## T10/06-451 revision 3

Date: November 17, 2006

From: George Penokie (IBM)

Subject: SAS-2: SAM-4: Miscellaneous State Machine Fixes

Figure 1 — SL (link layer for SAS phys) state machines (part 1)

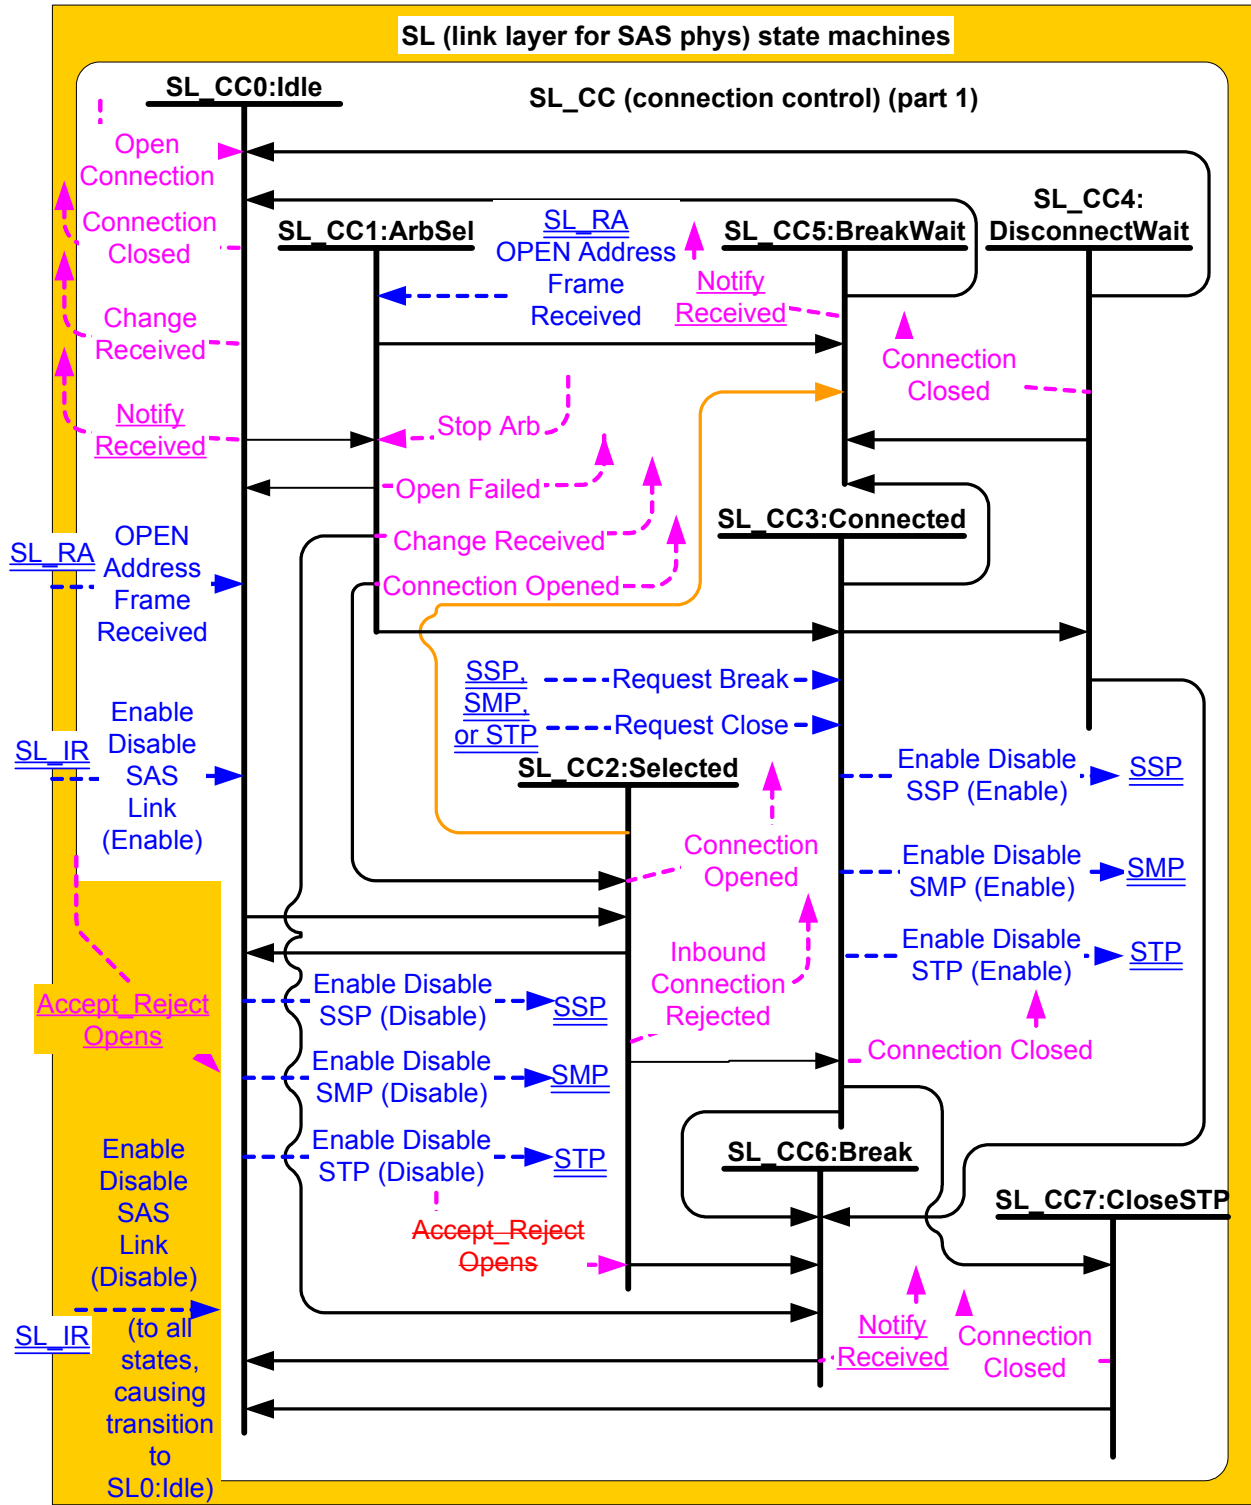
Editor's Note 3: Figure 1 has changed. The changes are indicated by the orange arrow and by underlines on the confirmations, requests, and messages.

Figure 2 — SL (link layer for SAS phys) state machines (part 2)

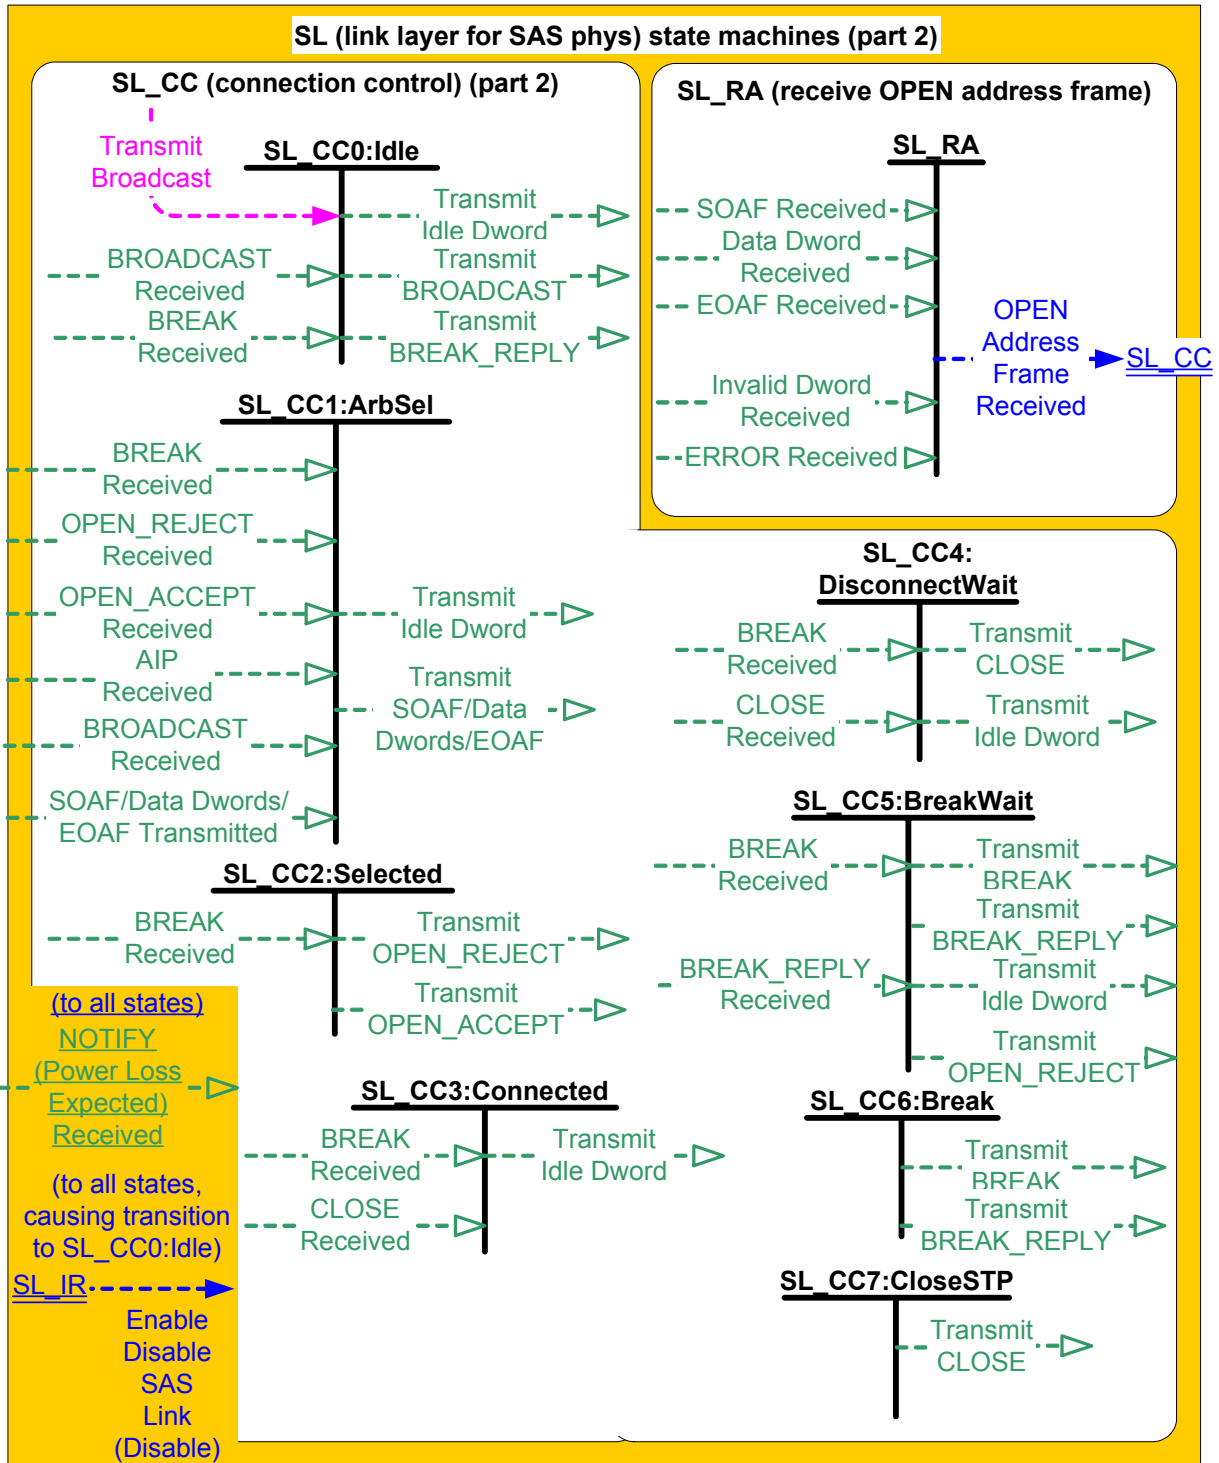
Editor's Note 4: Figure 2 has changed. The changes are indicated by underlines on the confirmations, requests, and messages.

Figure 3 — PL\_OC (port layer overall control) state machine

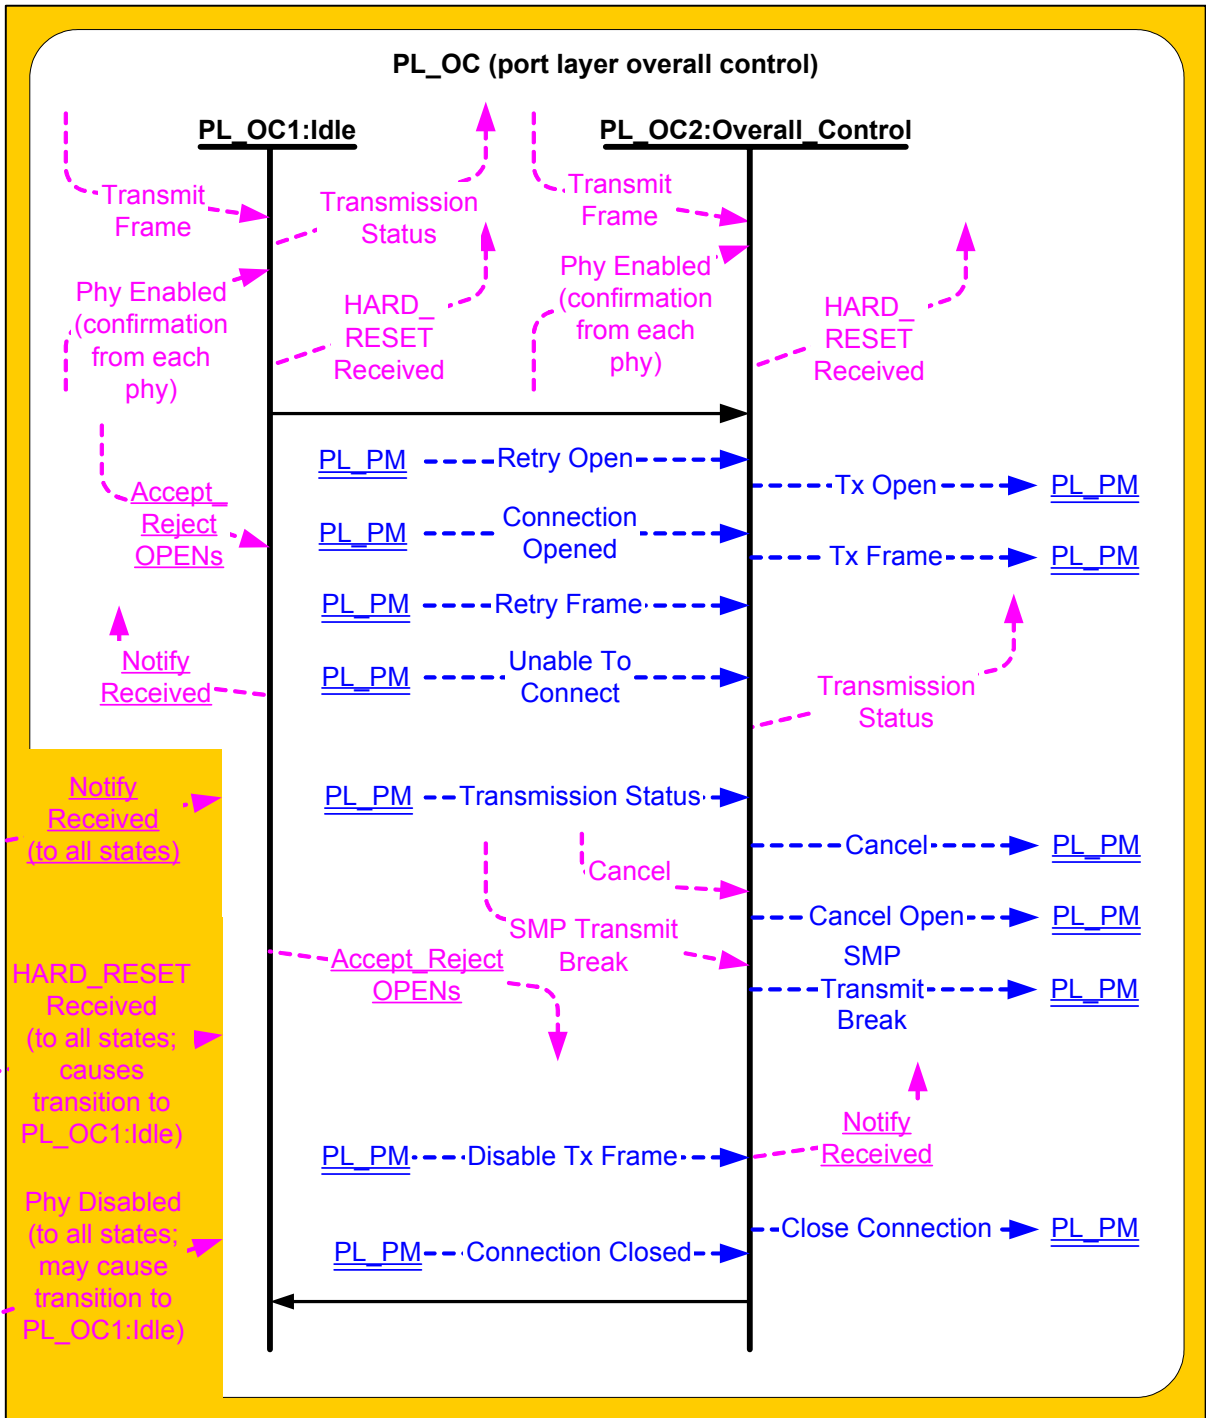
Editor's Note 5: Figure 3 has changed. The changes are indicated by underlines on the confirmations, requests, and messages.

Figure 4 — ST\_T (transport layer for SSP target ports) state machines

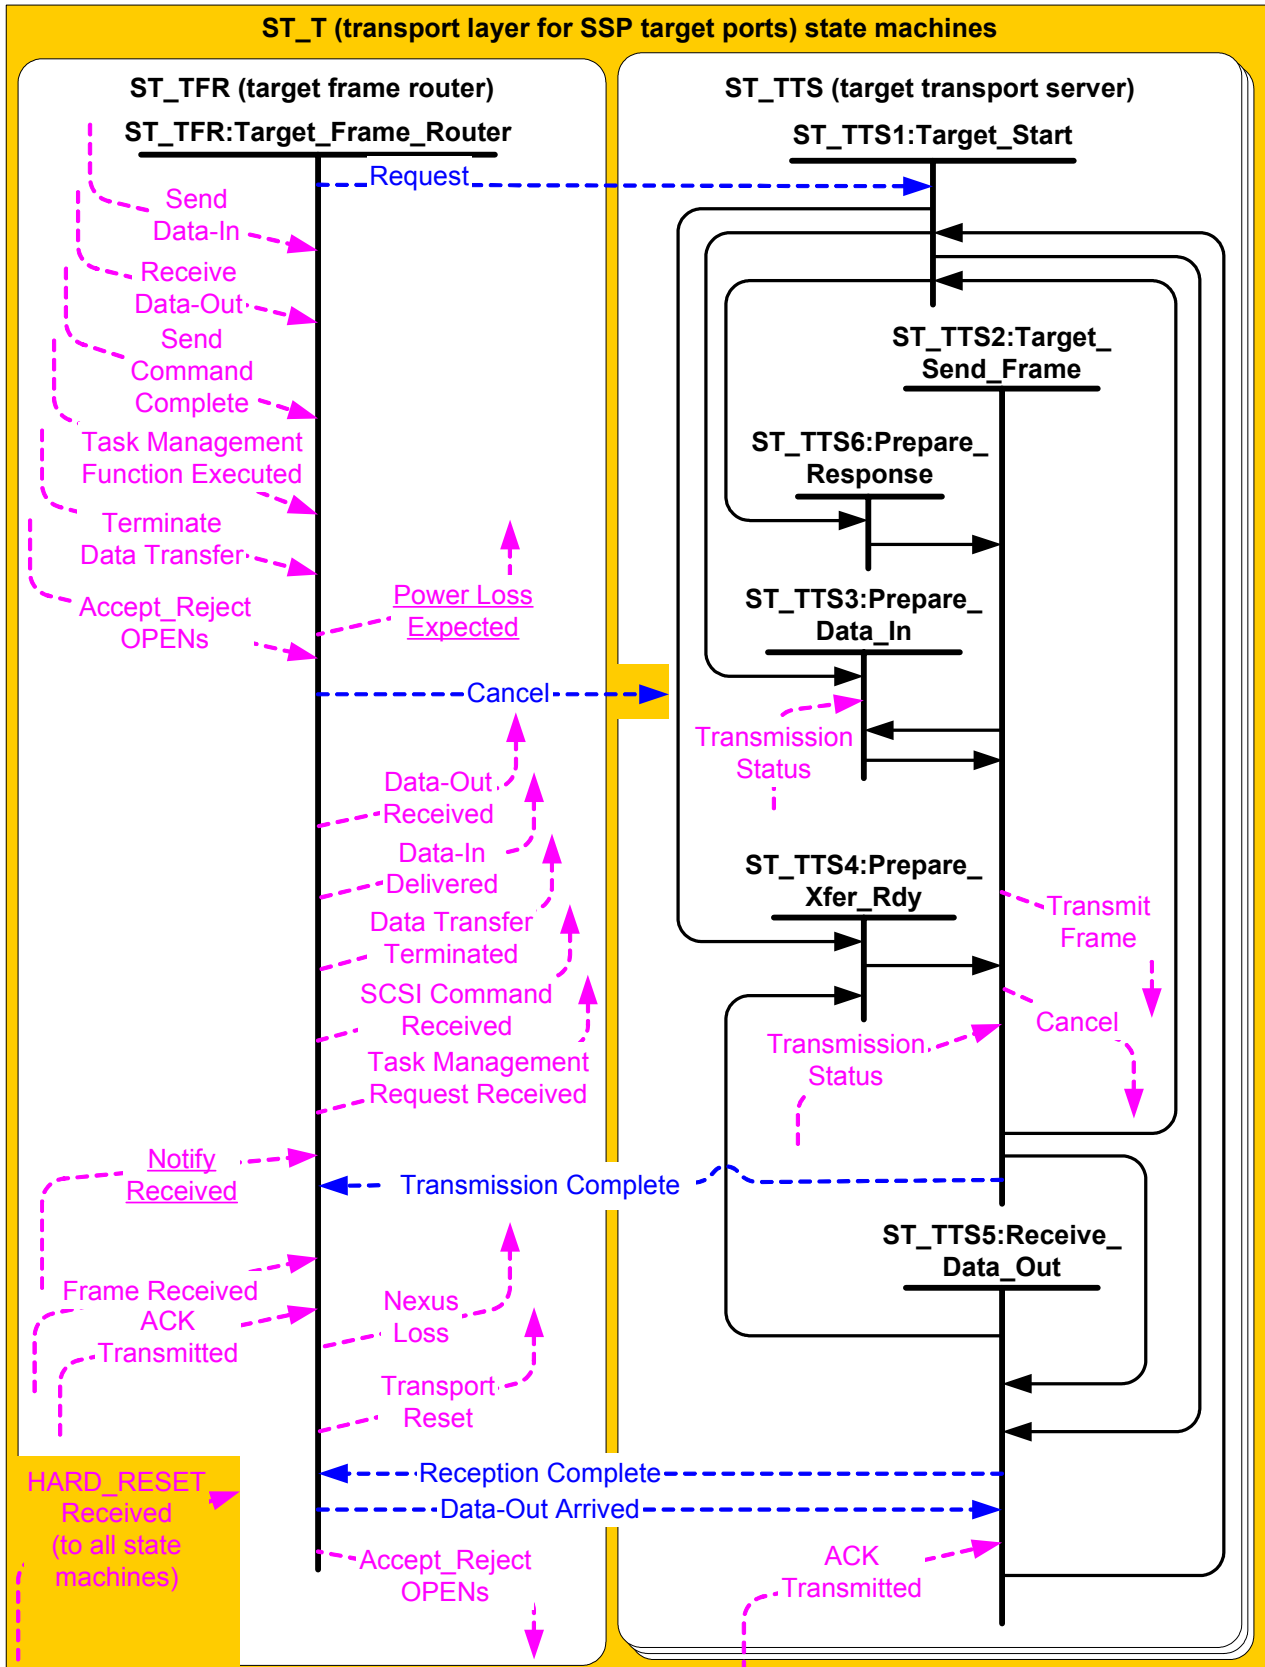
Editor's Note 2: There needs to be a Transmission Status confirmation arrow added to the ST\_TTS5: Receive\_Data\_Out state in the ST\_T state machine figure.

Editor's Note 6: Figure 4 has changed. The changes are indicated by underlines on the confirmations, requests, and messages.

Figure 5 — Events and event notifications for SCSI target devices

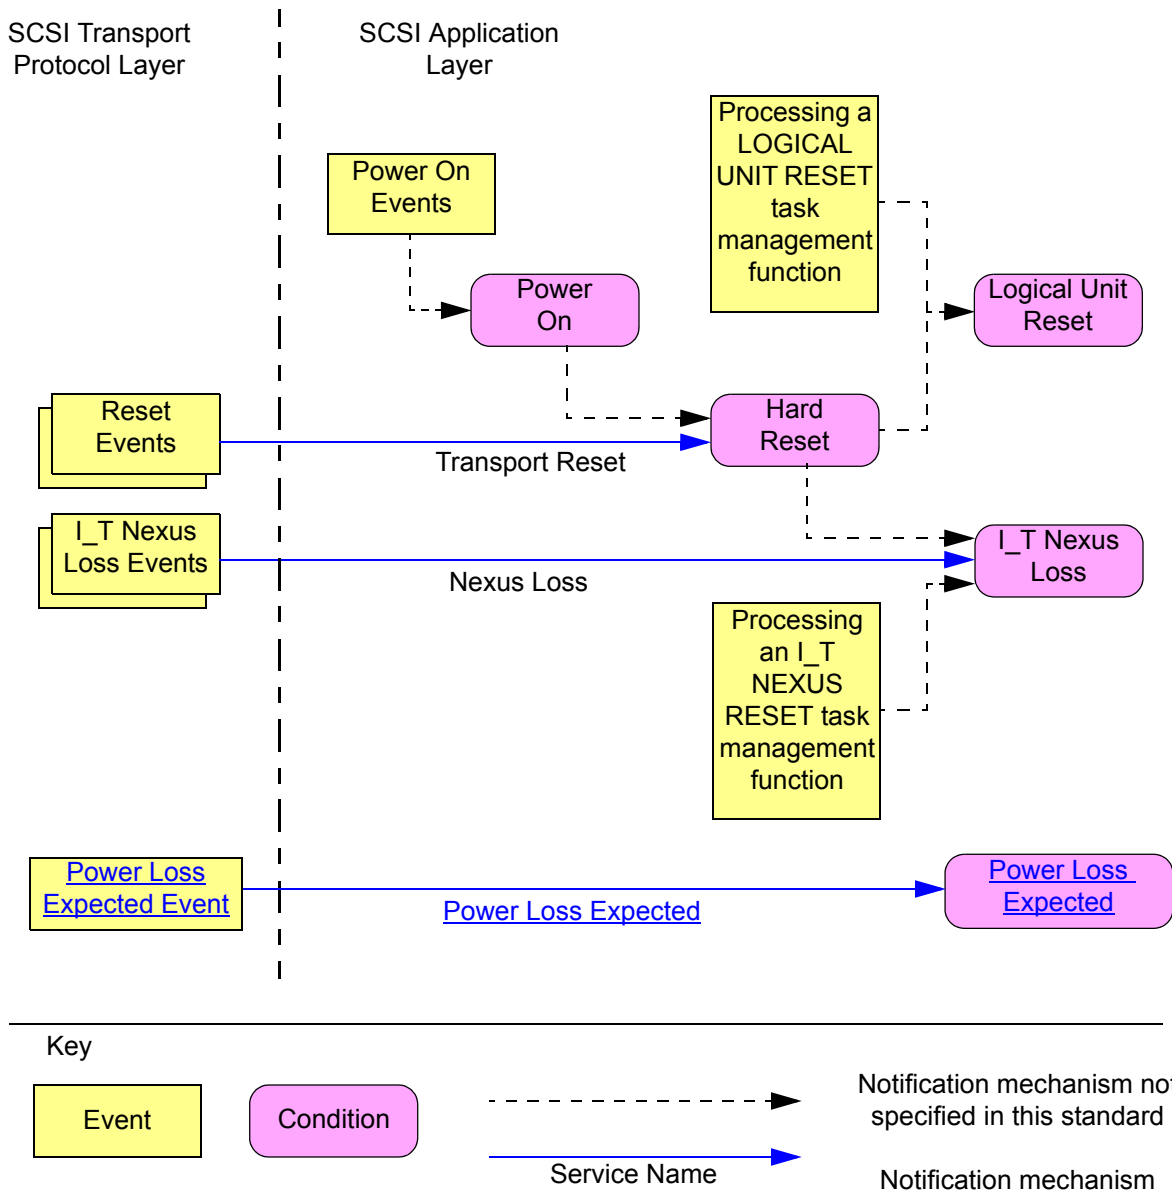
Editor's Note 7: Figure 5 has changed. The changes are indicated by blue underlines.
